Michael McGuirt - Request for Clarifications on Resource Evaluations and Impact Assessments

CEC REQUEST FOR CLAIRIFICATION
RESPONSE TO E-MAIL FROM M MCGUIRT DATED 3/26/09

Clarifications on Resource Evaluations

Site BSPL-H-02. View to the south.

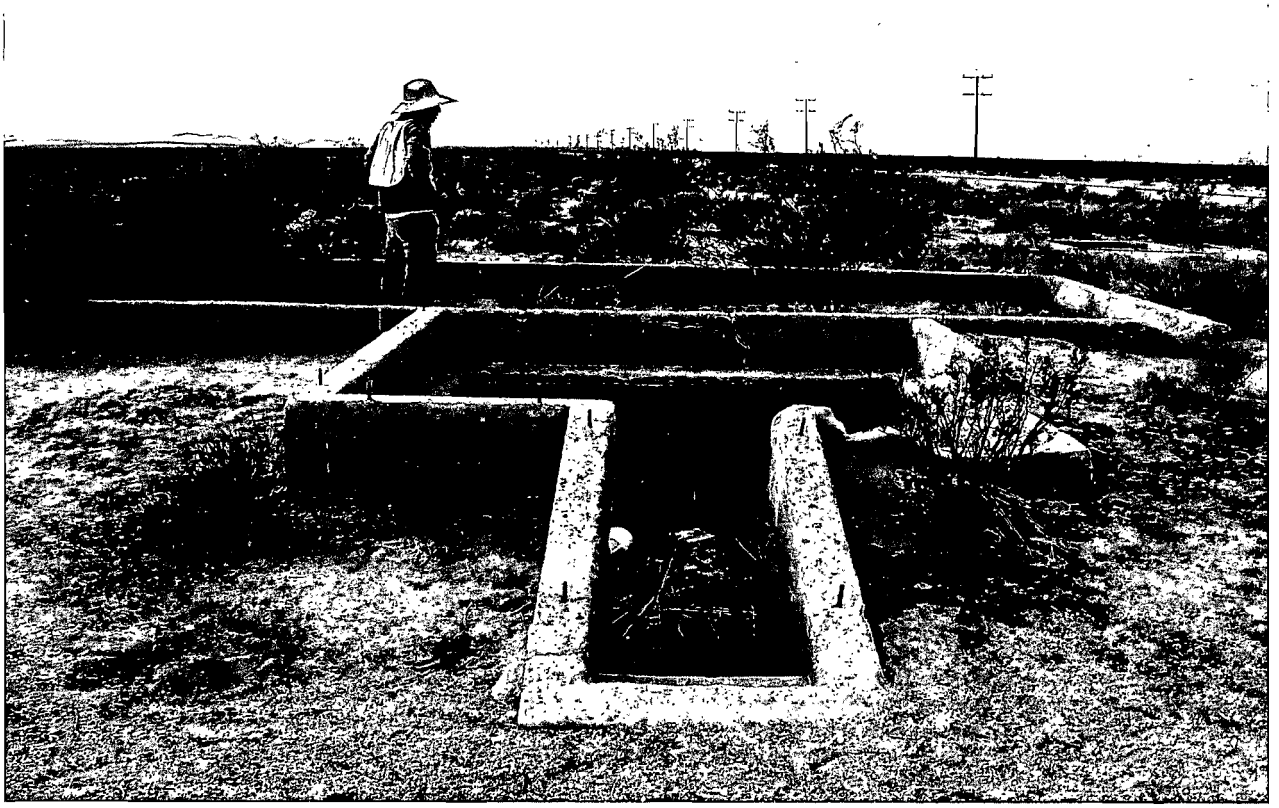
BSPL-H-02. This site appears to be approximately 20 meters east of Neuralia Road. The AFC indicates that the natural gas pipeline would be built in the ROW for that road. Is the site far enough away from the road ROW to make site avoidance feasible during pipeline construction? If FPL can commit to avoiding the site during pipeline construction, one option for the regulatory disposition of the resource would be to assume it eligible for listing in the CRHR, rather than completing the formal evaluation of the resource, and conditioning pipeline construction with explicit avoidance measures. How would FPL like to proceed here?

Response: FPL plans to confine all disturbance associated with the pipeline to Neuralia Road and the road shoulder based on cultural resource and biological concerns. Site BSPL-H-02 is several meters east of the road shoulder and the road (see below – Neuralia Road is visible in the upper right portion of the photograph). FPL will commit to avoiding the site BSPL-H-02.
